Office Action Summary

10/786,687

VOVES, MARK A.

Fig.2

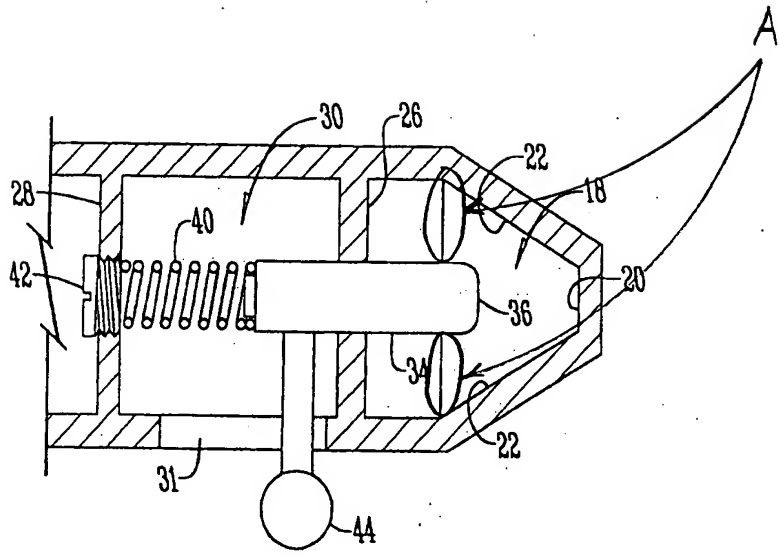
2. The drawings are objected to because in Figure 2, it is unclear what vertical lines (circled and labeled as "A" on page 7 of this office action) are. These vertical lines do not appear in Figure 3. It is unclear what these lines represent and should be deleted from Figure 2 or added to Figure 3 for consistency. Corrected drawing sheets in compliance with 37 CFR 1.121(d) are required in reply to the Office action to avoid abandonment of the application. Any amended replacement drawing sheet should include all of the figures appearing on the immediate prior version of the sheet, even if only one figure is being amended. The figure or figure number of an amended drawing should not be labeled as "amended." If a drawing figure is to be canceled, the appropriate figure must be removed from the replacement sheet, and where necessary, the remaining figures must be renumbered and appropriate changes made to the brief description of the several views of the drawings for consistency. Additional replacement sheets may be necessary to show the renumbering of the remaining figures. The replacement sheet(s) should be labeled "Replacement Sheet" in the page header (as
